Susitna-Watana Hydroelectric Project Document

Title (two memorandums): Task 1 - seismic setting review, Susitna Hydroelectric Project Geologic and geotechnical data reports review, Susitna Hydroelectric Project		SuWa 220
Author(s) – Personal: Bob Scher (first memorandum) Charles Riddle (second memorandum)		
Author(s) – Corporate: R & M Consultants, Inc.		
AEA-identified category, if specified:		
AEA-identified series, if specified:		
Series (ARLIS-assigned report number): Susitna-Watana Hydroelectric Project document number 220		Existing numbers on document: R&M No. 1158.21
Published by: [Anchorage, Alaska : Alaska Energy Authority, 2010?]		Date published: 2 July 2009 June 4, 2009
Published for: John Magee		Date or date range of report:
Volume and/or Part numbers:		Final or Draft status, as indicated:
Document type: Memorandum		Pagination: 7, [9], 6 p.
Related work(s): see notes below		Pages added/changed by ARLIS:
Notes: First memorandum is an evaluation of: <i>Final report on seismic studies for Susitna Hydroelectric Project</i> / prepared by Woodward-Clyde Consultants. 1982. (APA 1255-1256 and 1434) Second memorandum consists of excerpts from <i>Volume 12, Exhibit E, Chapter 6,

**FIGURE 1: Effect of Attenuation Models on the Mean
5% Damping Ratio Response Spectra, Watana Site**

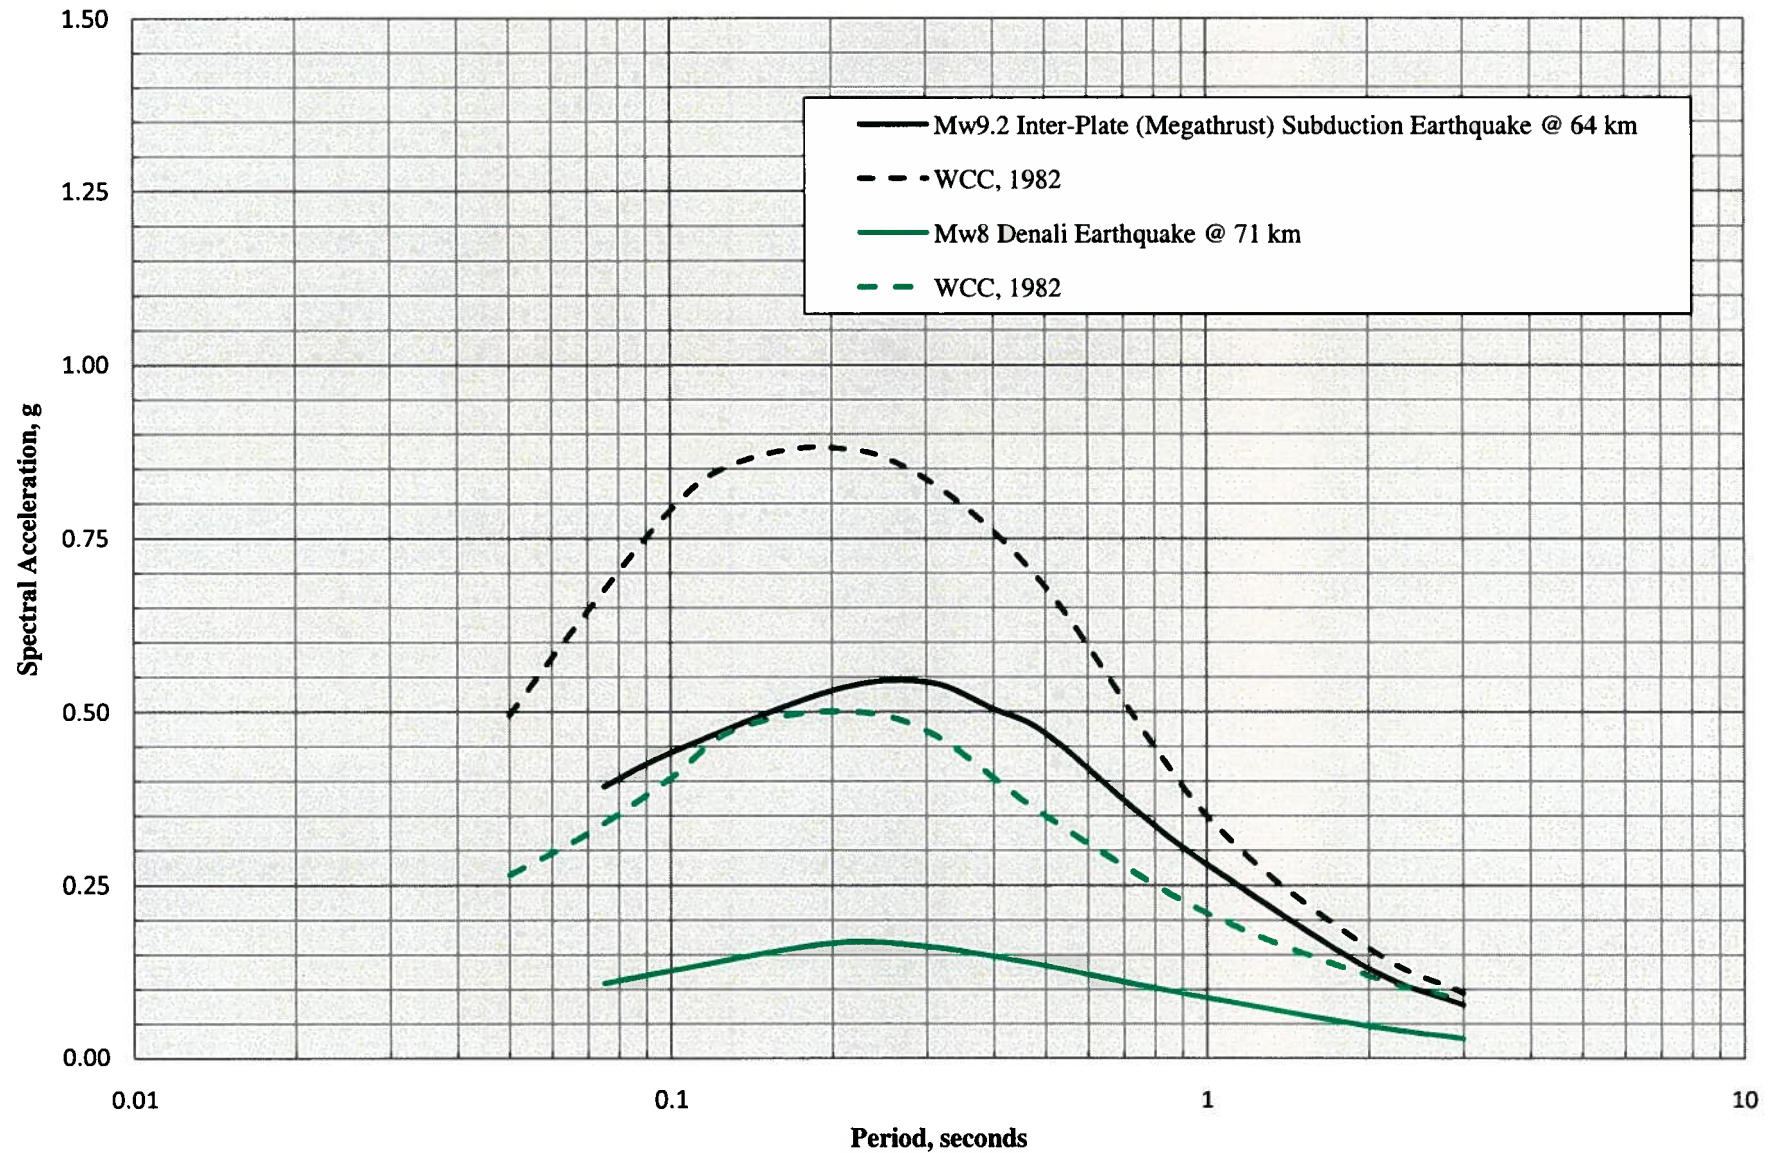
Figure 1 compares the mean horizontal acceleration response spectra provided in WCC (1982) for MCEs generated on both the megathrust subduction zone and Denali fault, with the spectra we predicted using the weighted combination of newer attenuation models listed in Table 2. From inspection, the more recent attenuation models suggest that design ground motions in the SHP area may be lower than considered at the time of the WCC studies; at least for structures with fundamental periods less than about 2 to 3 seconds.

**FIGURE 4: 5% Damping Ratio Response Spectra
for the WCC "Detection Level Earthquake"**

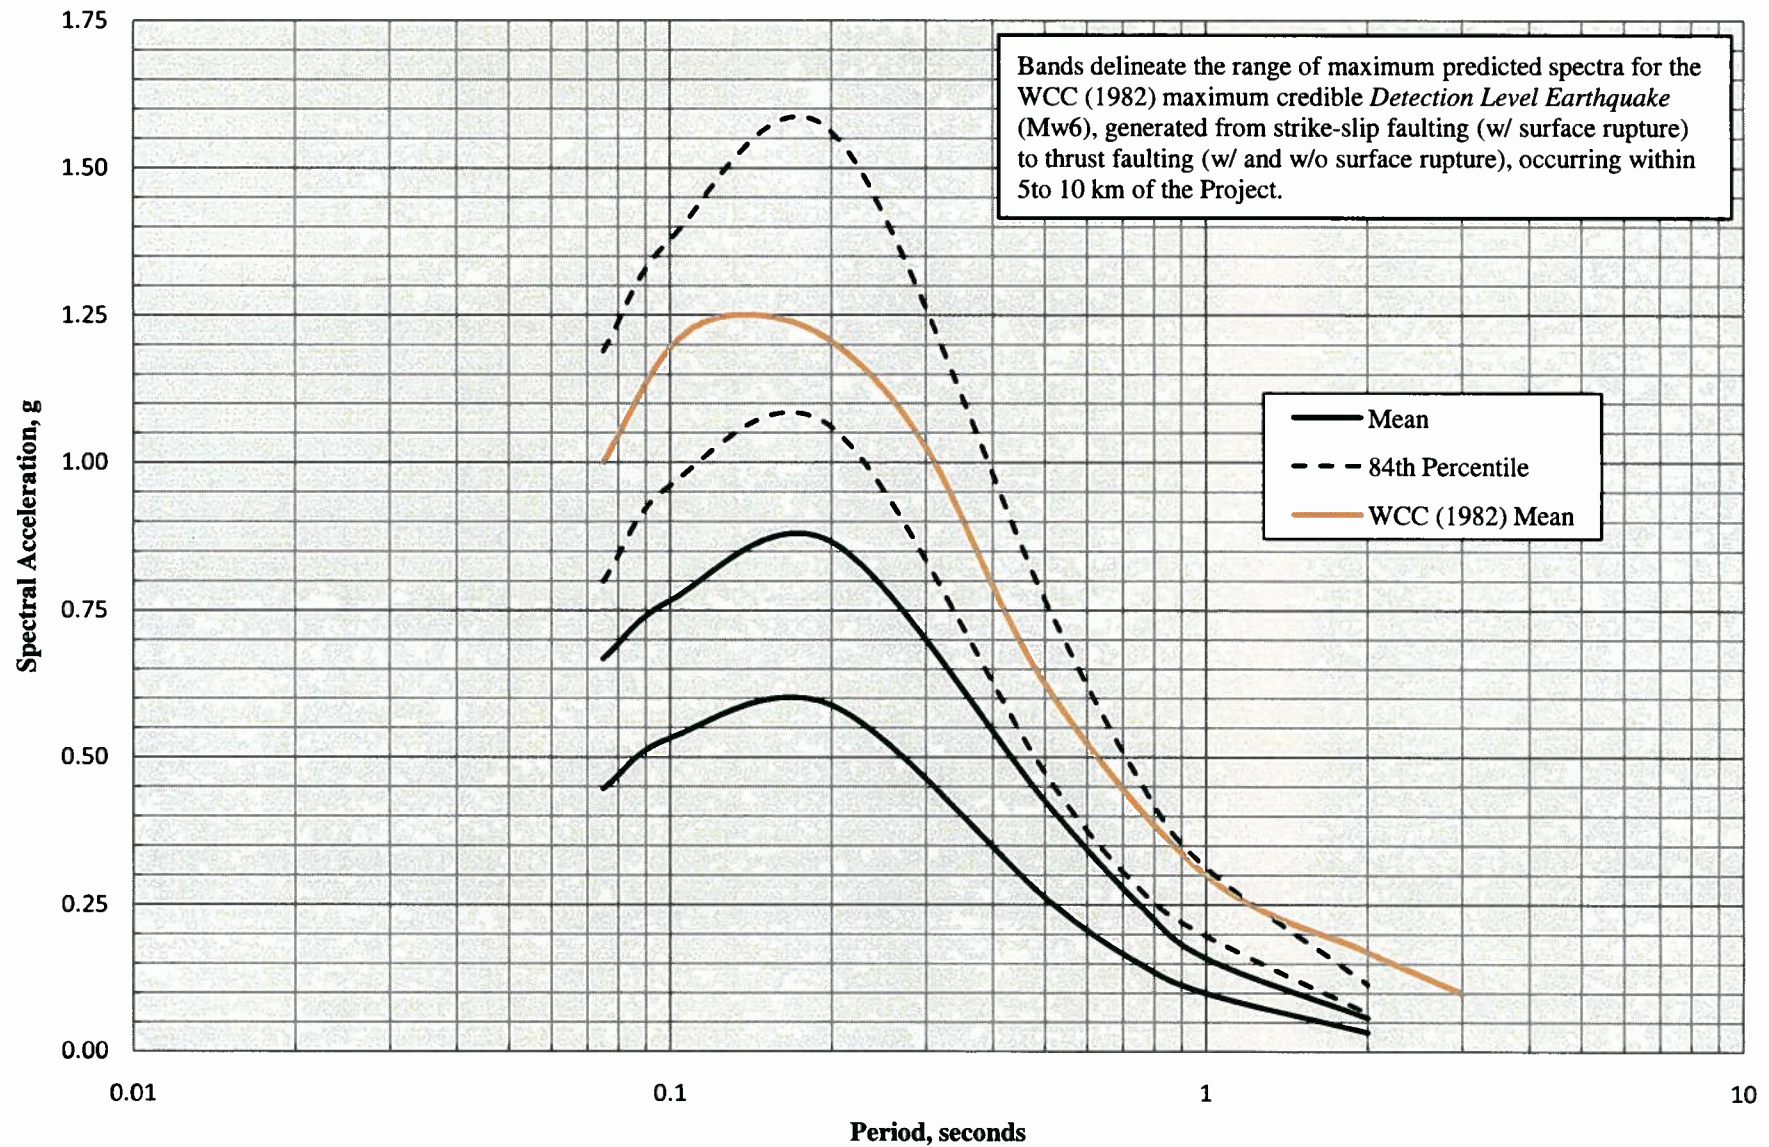
Based on our evaluations, we concur that a moderate, but very close earthquake could be expected to produce the strongest ground motions at the project site. Table 3 and Figure 4 respectively illustrate the 'range' of PHGA and spectral ground motions we predicted for an M_s 6 earthquake, generated from strike-slip or thrust faulting within 5 to 10 km of the project site, using the attenuation models for crustal sources listed in Table 2. However, contrary to WCC (1982), the current USGS on-line programs indicate that a moderate, local earthquake may account for a more significant portion of the total probabilistic hazard (e.g. possibly on the order of roughly 20 to 40% depending upon the return and spectral periods).

FIGURE 5: 84th Percentile 5% Damping Ratio Response Spectra at the Watana Site for Active Sources

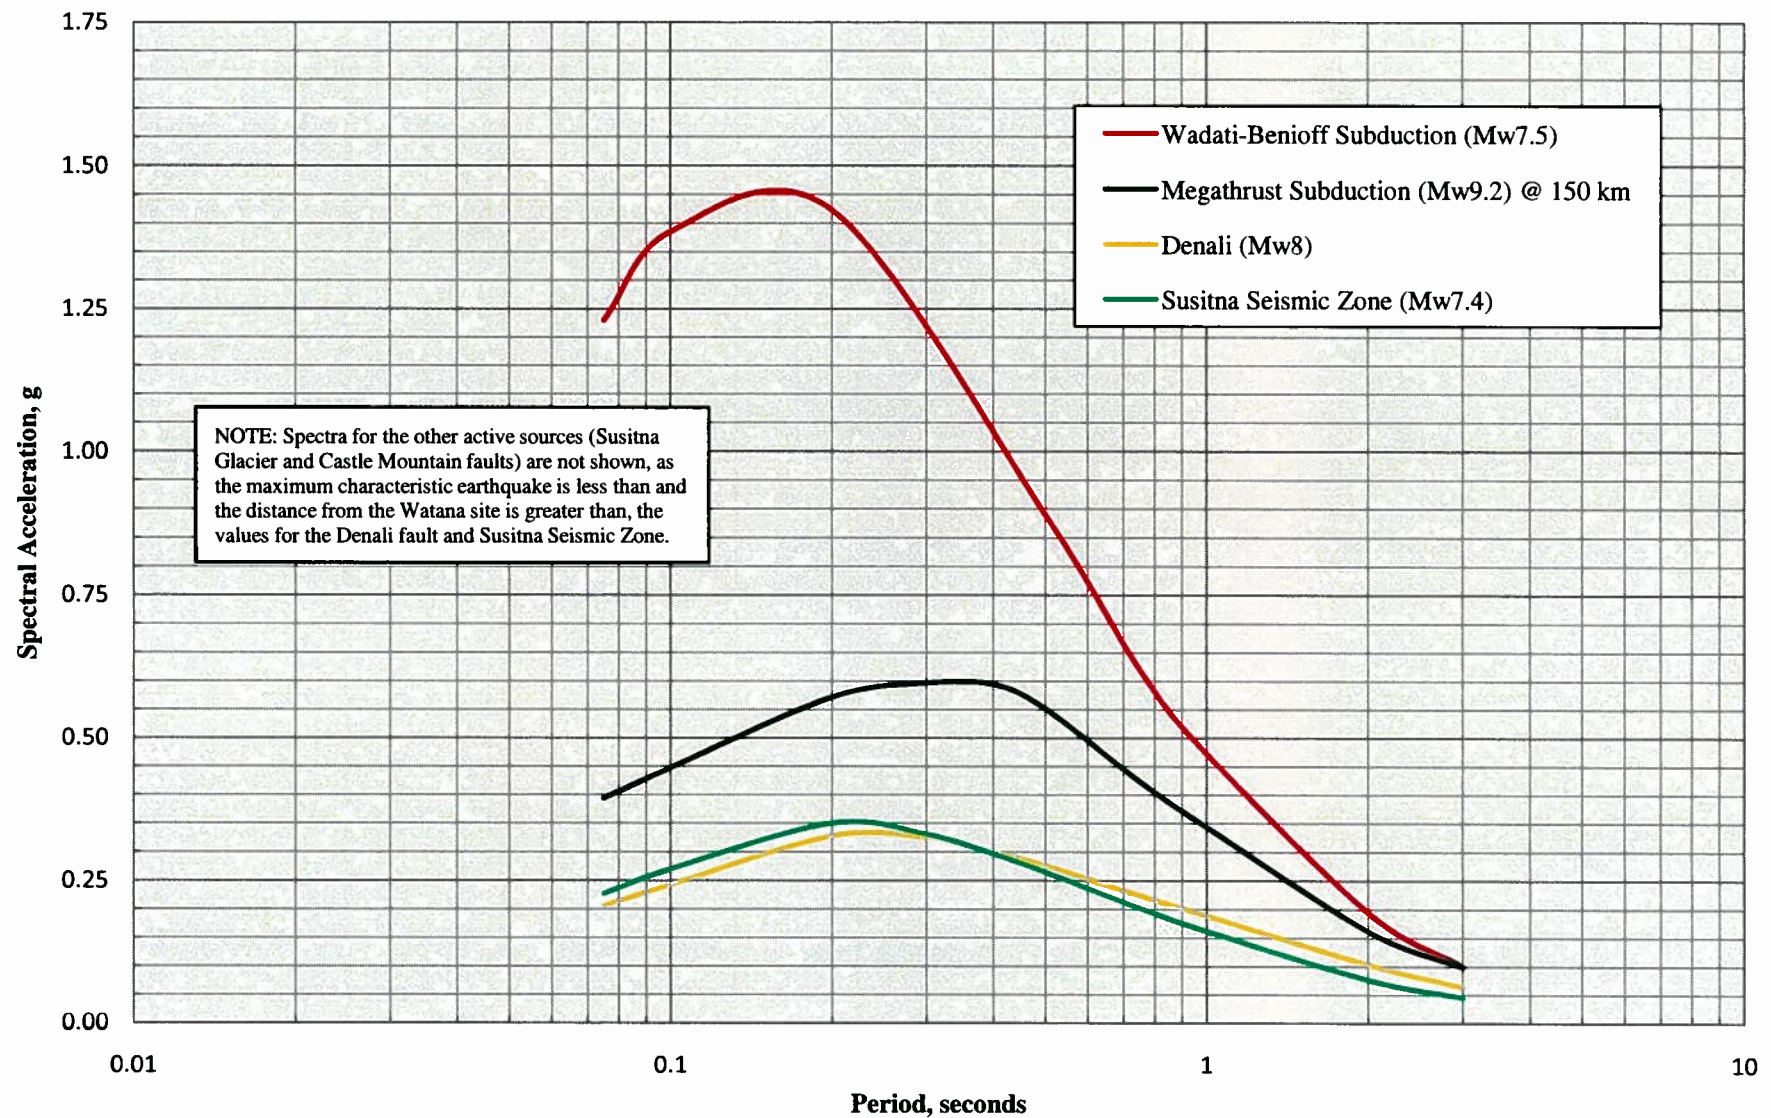
The significance of this point is illustrated in Table 3 and Figure 5, which compare respectively the PHGA and 84th percentile response spectra predicted at the Watana site for each of the seismic sources described in Table 1, using the attenuation models in Table 2.
